Subject: Requested Assurances - Vancouver Island Rail Corridor Infrastructure Improvement - Project Funding Request

Presentation to BC Ministry of Transportation & Infrastructure – March 13, 2015

RTC Report Review / Questions

3.9.6 Tie Plates

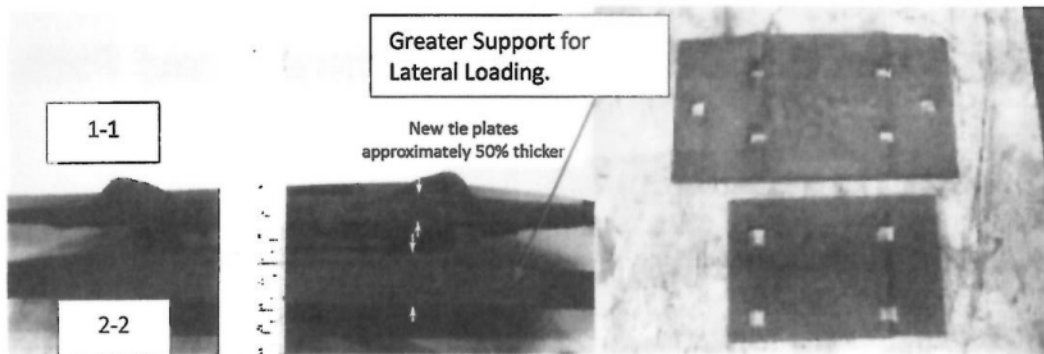
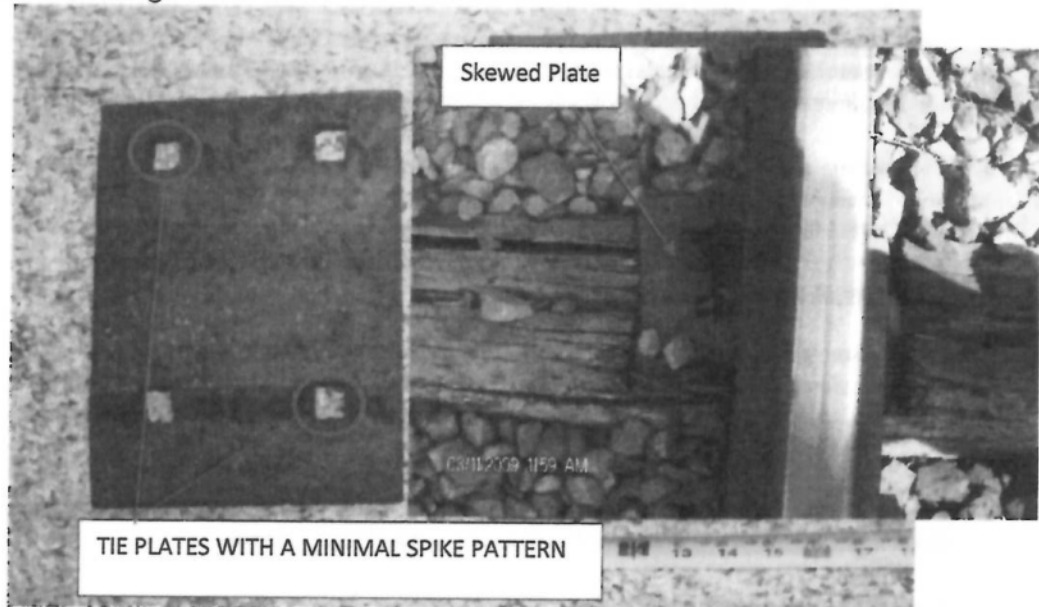
The last paragraph on page 20 states, in part, "Double shoulder tie plates are about 60% larger than single shoulder tie plates." This statement is also technically inaccurate and over-stated. The standard single should tie plate used on the VIRC is 9 inches wide by 6 ½ inches long or 58 ½ square inches in area. The standard double should tie plate used is 7 inches long by 10 inches wide or 70 inches in area. This represents an increase in surface area of less that 20% for double should plates in comparison to single shoulder plates. This does represent a greater bearing surface on the tie however the magnitude of that change (and resulting effect) has been significantly over-stated.

Do note that in the above photos illustrated 1-1 is a double shoulder plate which is normally thinner than a single shoulder. Additionally both photos illustrate a 5 ½ inch base used for 100lb rail. Rather than the 5 3/16 for 85lb rail presently in place at the VIRC. As per below this reinforces the importance of not only better tie plates but rail upgrades to at least 100lb. in key locations.
